Access Compliance Report Public Rights-of-Way (Curb Ramps)

Main Street: BOSTONIAN_DR Cross Street: KENSINGTON_RD Location: NW

ADA ID: RPRK211220130410 Ramp Type: Type 1 - Perpendicular Diagonal Initial Pass/Fail: Pass Overall Compliance: No Severity Score: 4

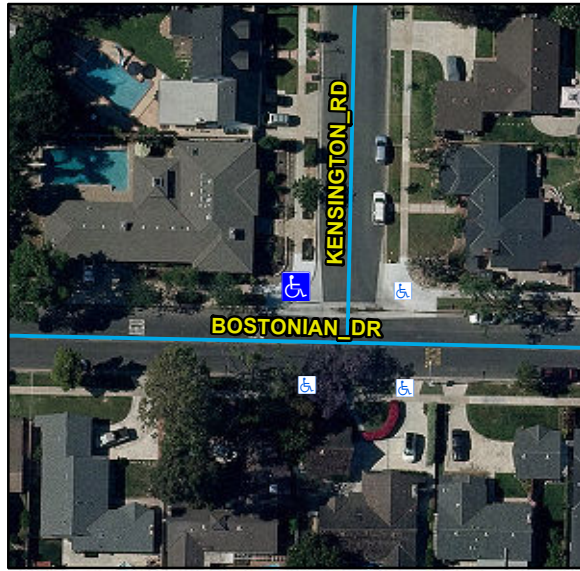
Remove & Replace Landing. Gutter Ponding Observed.

R304.2.1, R302.7, STD 1115

Possible Solutions:
